Enclosed please find the revised Definitive Plan (Sunshine Ridge) submitted by:  
Bailey Road Development, Inc.  
P.O. Box 413  
Rutland, MA. 01543

RE: Definitive Subdivision – 160 Bailey Road

**Definitive Subdivision Plan  
Sunshine Ridge  
Located on  
Bailey Road  
Holden, Massachusetts**

**Sewer Capacity  
Calculations and  
Fire Flow Calculations  
Section VI E.2.b.(i)**

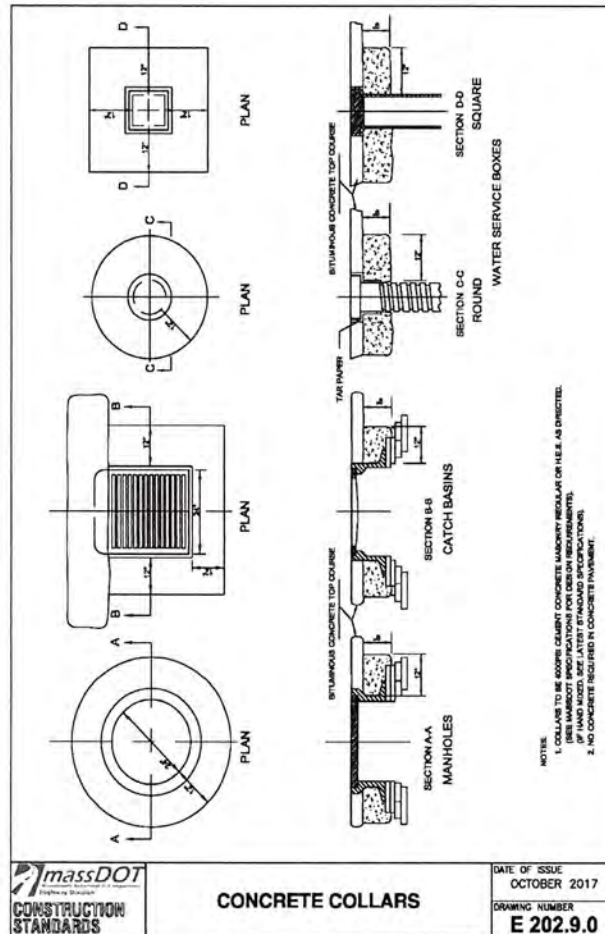
22. Add a minimum setback requirement of 10 feet from any poles, catch basins and hydrants to the driveway detail shall be maintained.

*This requirement has been met and a note stating the requirement has been added to typical driveway detail on Sheet D-02.*

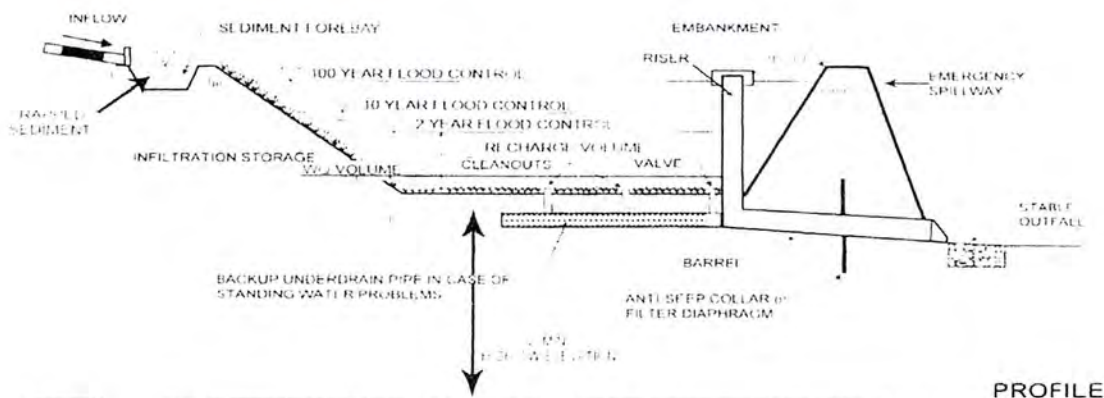
38. At least 1-ft of freeboard shall be provided for both BMPs from the 100-yr storm elevation to the emergency spill elevation. As proposed, the Detention Pond will overflow under the 100-yr storm conditions. Add to Sheet D-05, the elevations of the emergency spill for the basins.  
*The spillway elevations for the emergency spillways for each basin have been added to the revised Sheet D-05. 1-ft of freeboard between the 100-year storm elevation and the spillway is not a requirement per Stormwater Standards that needs to be met for these BMPs. These BMPs would be considered non-jurisdictional when concerning the Office of Dam Safety as neither hold back 15 acre-feet of water and neither have an embankment height in excess of 6 feet. Both BMPs have been sized to detain and/or safely pass the 100-year storm through their spillways.*

*The infiltration basin is designed so that the 100-year storm elevation is slightly lower than the spillway. The Massachusetts Stormwater Handbook allows for a basin to be designed to the brimful condition for a 2-year, 10-year, and 100-year storm as noted on page 91 in Volume 2, Chapter 2 of the handbook.*

*The detention basin is designed with a spillway capable of passing large storms as required by the Massachusetts Stormwater Handbook. The detention pond does not overtop during the 100-year storm as the BMP/spillway has been designed to safely pass the 100-year storm.*

*The image of a detention basin below was scanned from the Massachusetts Stormwater Handbook – Structural BMPs – Volume 2, Chapter 2, page 109. There is a similar image for an infiltration basin on page 87. The image below shows the 100-yr storm elevation above the emergency spillway and the 10-yr storm elevation at a brimful condition. Stormwater Management Requirements have been met for the designed BMPs and 1-ft of freeboard between the 100-yr storm elevation and the spillway is not a requirement for these BMPs.*

# MASS DEP PRIORITY RESOURCE MAP

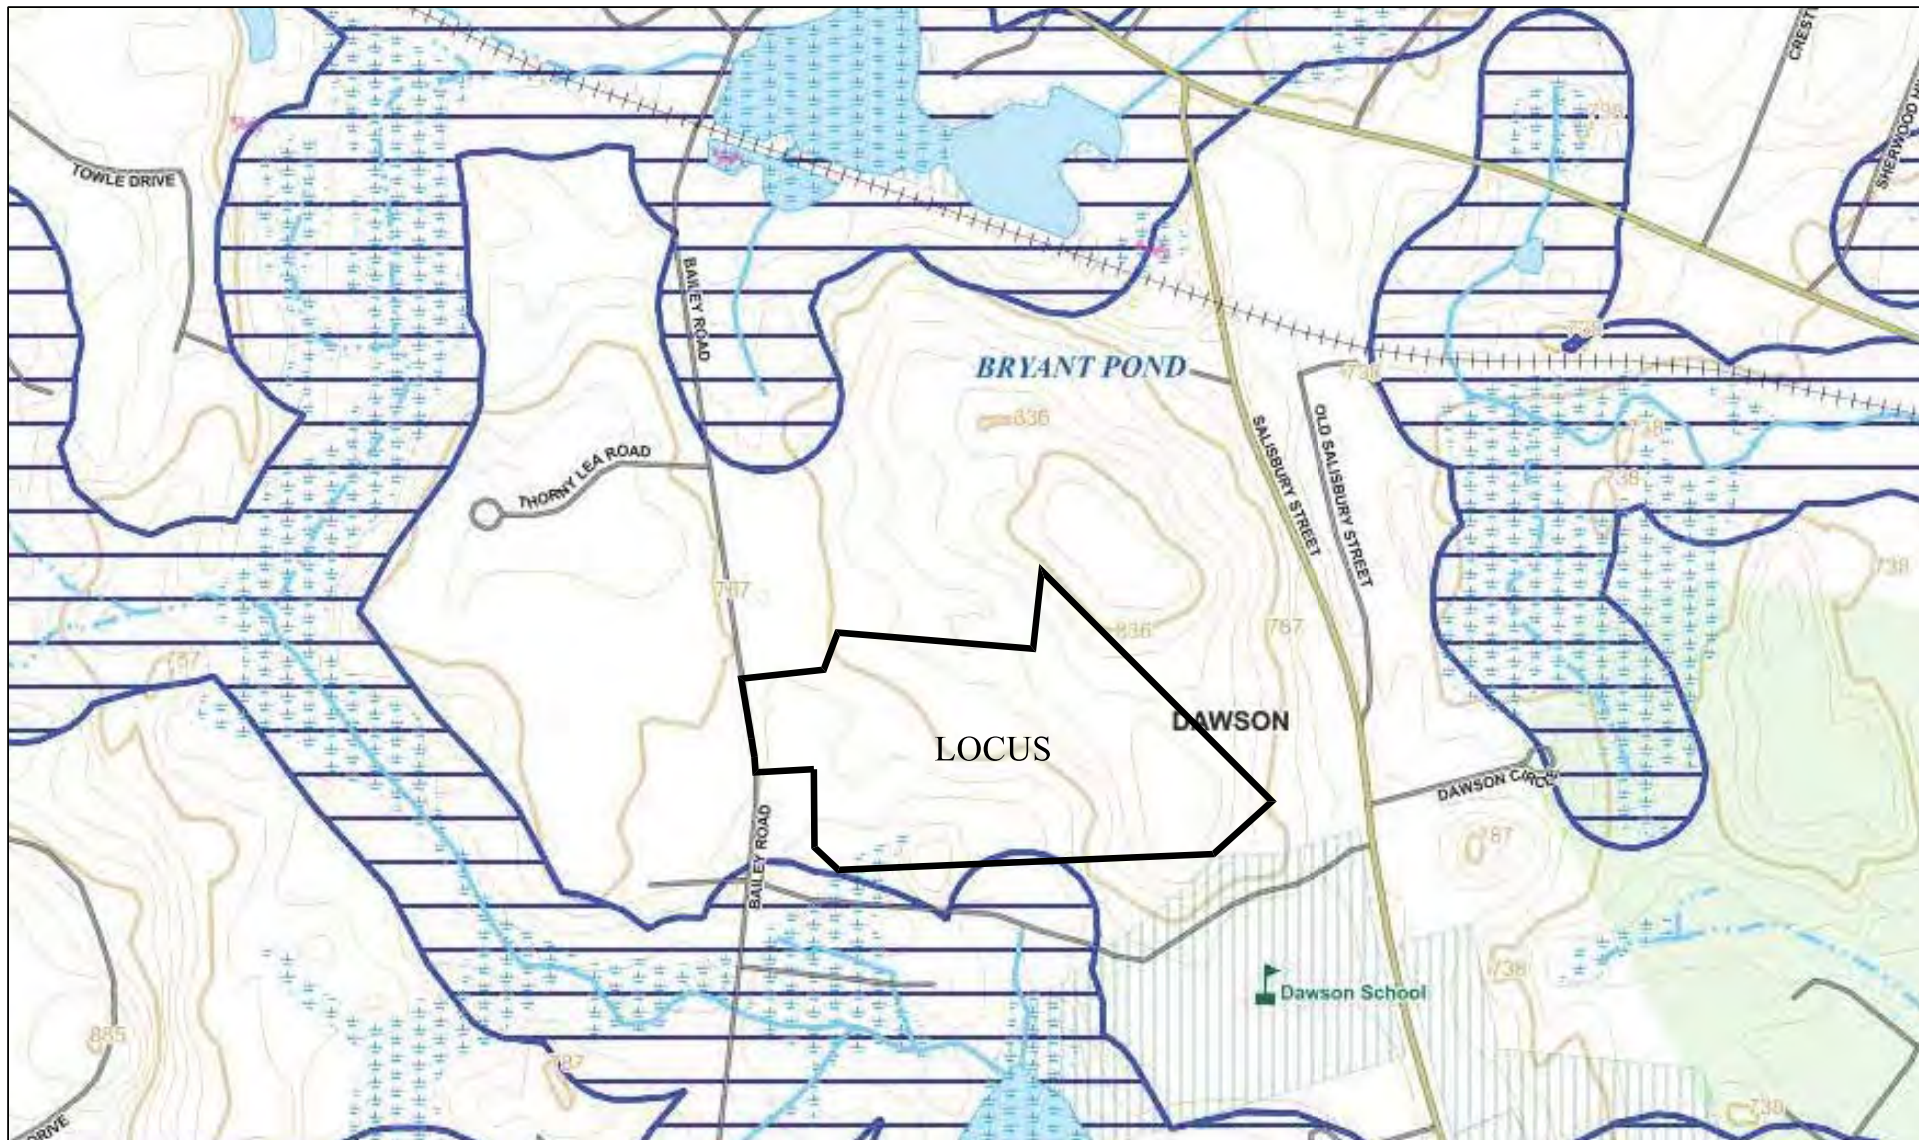
44. Under the submittal package add the parcel layout to all environmental figures ie. DEP Priority Resource Map and Title V, etc., and resubmit. It is unclear what the overlap to these sensitive areas is because the parcel layout is missing.  
*The parcel layout has been added to the maps in question. (see attached)*
